IDAP REPORT

Property:	61 Cotswold Road Strathfield Lot: 17 DP: 9590 DA2020/177
Proposal:	Demolition of all existing structures and construction of a new two-storey dwelling over basement with a lift, a landscaped courtyard feature that is open to the weather and visible from all three levels by way of glass windows, an in-ground swimming pool and front fence.
Applicant:	Vision Group Architects
Owner:	R Dojas
Date of lodgement:	4 November 2020
Notification period:	13 November 2020 to 30 November 2020
Submissions received:	Nil
Assessment officer:	P Santos
Estimated cost of works:	\$1,575,159.00
Zoning:	R2 - Low Density Residential - SLEP 2012
Heritage:	No
Flood affected:	No
RECOMMENDATION OF OFFICER:	APPROVAL

Figure 2. Extract of the site plan, (source: Vision Group Architects, sheet 02 issue C, dated Feb. 2021).

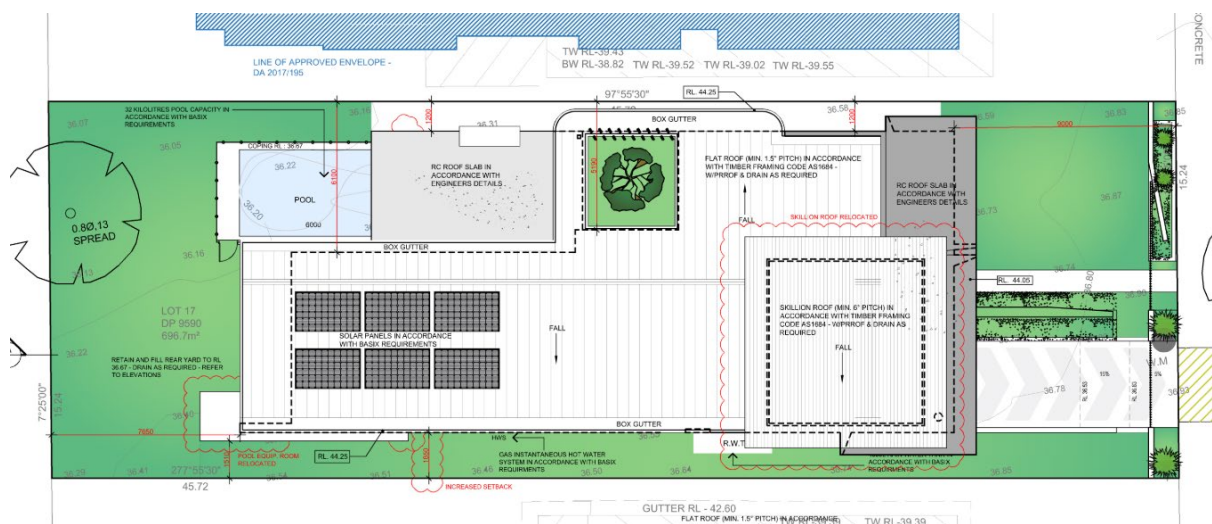
The proposed development's initial design was a flat roof. See Figure 11 below. The applicant was requested to address the streetscape and its predominant character of pitched roof dwellings. The most recent design was provided to council with a more acceptable outcome as it addresses the pitched roof component of the streetscape. See Figure 12 below. The proposal had introduced a skillion roof over the southern half of the dwelling's façade as a response to the street's pitched roof character.

Figure 13. Extract of the landscape plan (source: Dapple Designs, LP 01 sheet 1 of 3, dated 03/02/2021).

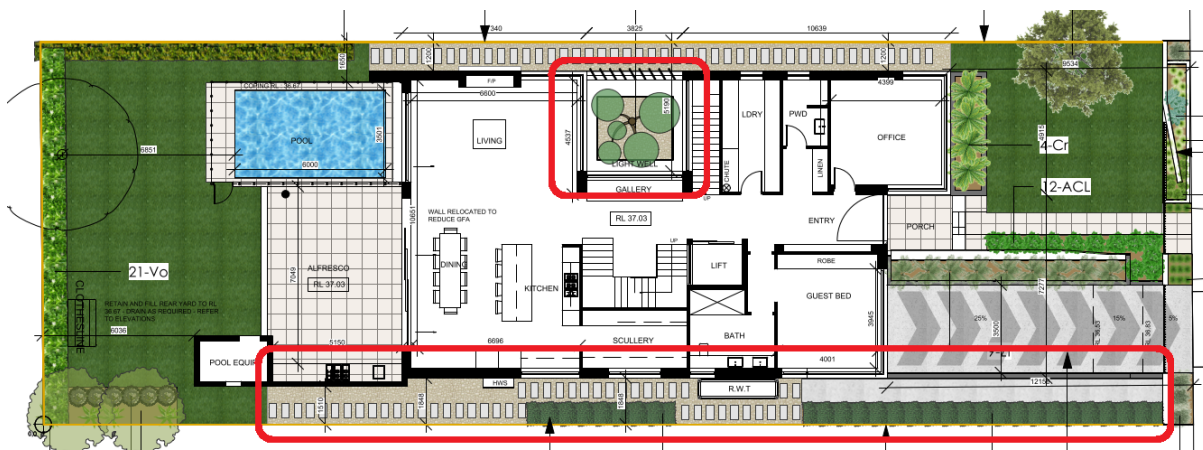
Figure 2 above shows that the southern area between the dwelling and the side boundary fence, and within the courtyard as landscaping. The landscape plan below shows the areas as either covered in pebbles or concrete. See Figure 13 below.

The proposed landscaping on the site 32% (222.8m²), where the requirement under the SCDPC 2005 is 41.5% (288.67m²), presenting a 22.8% variation. The proposal in its current state is not supportable.

The area outlined on the southern side of the property in Figure 13 will be conditioned to be changed to landscaping. This will result to a landscaping total of about 265.6m², which still falls short of the council control. As such, to address the non-compliance, council will require an additional tree to be planted within the front yard of the property. This tree will contribute to

Figure 14. Extract of the proposed basement floor plan (source: Vision Group Architects, sheet 01 issue C, dated Feb. 2021).

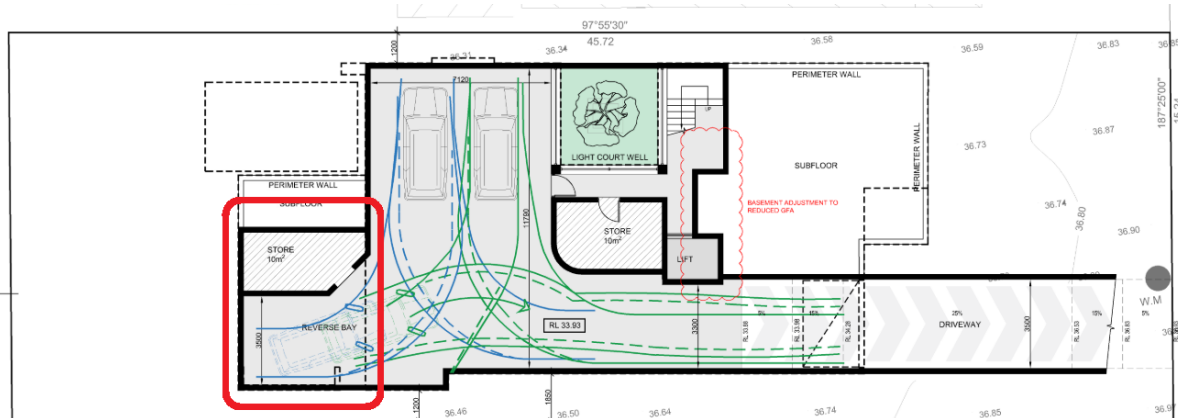
The proposed basement is considered to be outside the footprint of the ground floor (Figure 14). The outlined area in the image below shows that there will be an excavation underneath the alfresco area, which is not considered to be within the footprint of the dwelling at ground level. However, it is recognised that the area for the purpose of vehicle manoeuvring is necessary and will therefore be accepted. It is considered that this will not have any adverse environmental impact and the amenity of the neighbouring properties, in relation with the excavation component, will be protected by way of requiring a dilapidation report.

The storage component within the outlined part of the image below will be required to be relocated to minimise the amount of excavation beyond the ground level's footprint that will be needed to carry out the development. The second storage space will be conditioned to be relocated adjacent to the lobby and lift. In this regard, the proposed development is acceptable and supported.
